Site Accessibility Evaluation

Fire Station 2

**314 E San Miguel St
Colorado Springs, CO
80903**

SUBJECT: Fire Station 2 Self-Evaluation

Finding: 1

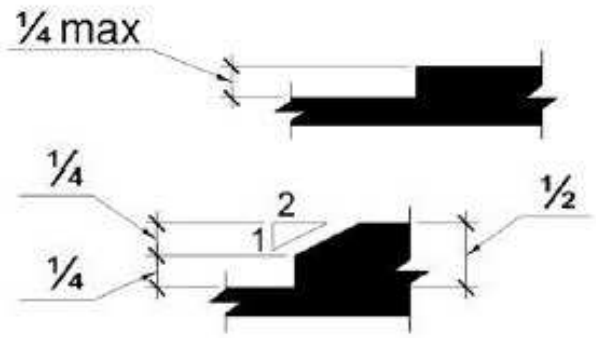
These three concrete pads have vertical displacement up to 1/2" due to fracturing in the concrete. The fracturing is also causing cross slopes up to 3.2%.

The walkway contains abrupt vertical edges and/or variations over a 1/4 inch.

2010 ADAS Section: 303.3, 303.2

Three concrete pads are in disrepair.

Remove and replace the concrete.

Finding: 2

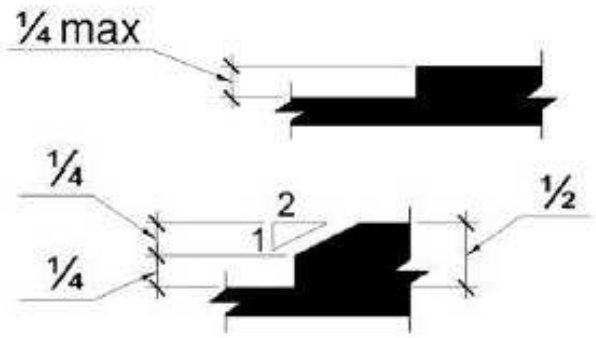
The sidewalk has a 1-1/2" wide by 7" long by 1/2" deep gap in the concrete.

The walkway contains abrupt vertical edges and/or variations over a 1/4 inch.

2010 ADAS Section: 303.3, 303.2

The walkway has a gap in the concrete.

Remove and replace a portion of the panel or this pad.

Finding: 3

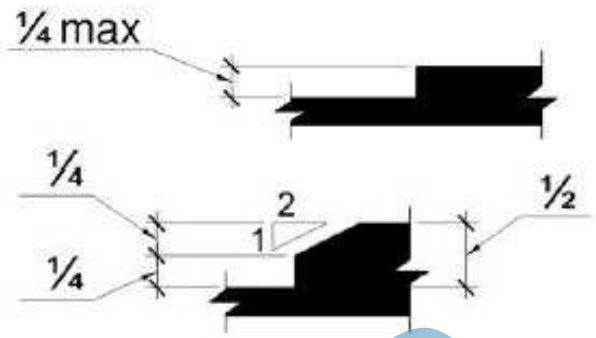
The walkway contains abrupt vertical edges and/or variations over a 1/4 inch.

2010 ADAS Section: 303.3, 303.2

The sidewalk has vertical displacement up to 1".

Grind the area to less than 1/2" or replace due to vertical displacement and cross slope.

Finding: 4

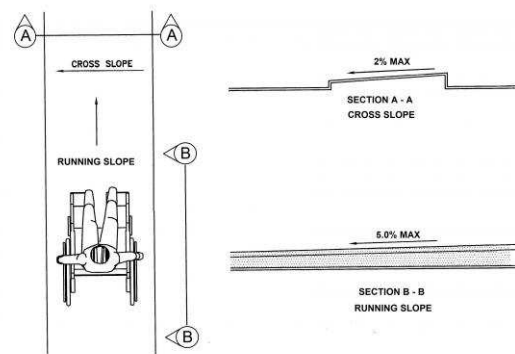
The accessible route of travel on the walk or sidewalk contains cross slopes greater than 2%.

2010 ADAS Section: 403.3

The cross slope of the accessible route within the driveway is up to 3%.

Remove and replace panels as feasible to create a pedestrian access route.

Finding: 5

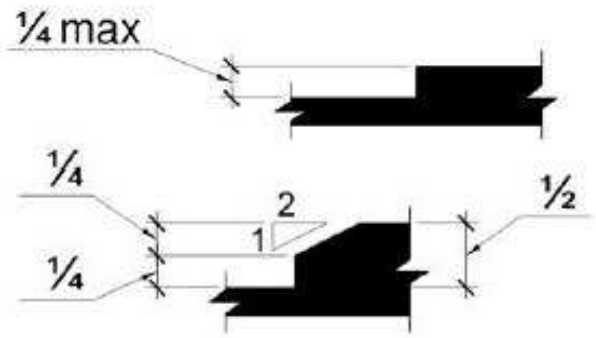
The walkway contains abrupt vertical edges and/or variations over a 1/4 inch.

In addition to the vertical displacement between the concrete and flagstone, the joints in the flagstone are deteriorating.

2010 ADAS Section: 303.3, 303.2

There is 1/2" vertical displacement between the concrete and the flagstones.

Explore methods of filling the joints in flagstone and reducing the vertical displacement between the materials or simply tear out and replace.

Finding: 6

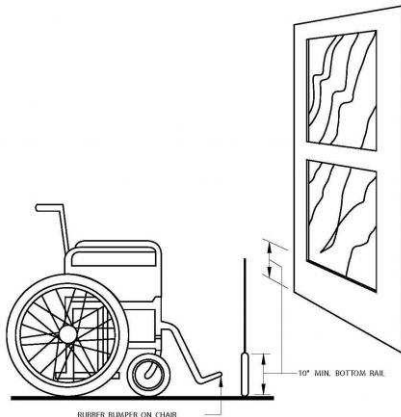
The door has a door stop which prevents it from having a smooth surface at the bottom.

2010 ADAS Section: 404.2.10

The front door has a door stop.

Replace the door stop with a different hold open device that does not impede wheelchair access.

Finding: 7

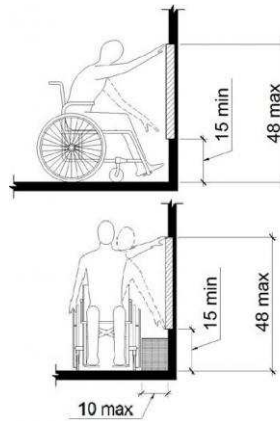
The door bell is positioned too high for either a side or front approach.

2010 ADAS Section: 308.1

The door bell is mounted at 50-1/2".

Lower the door bell to maximum 48" high.

Also, keep a 30" x 48" clear area at the door bell to allow for approach. The snow shovels need to be stored outside this area.
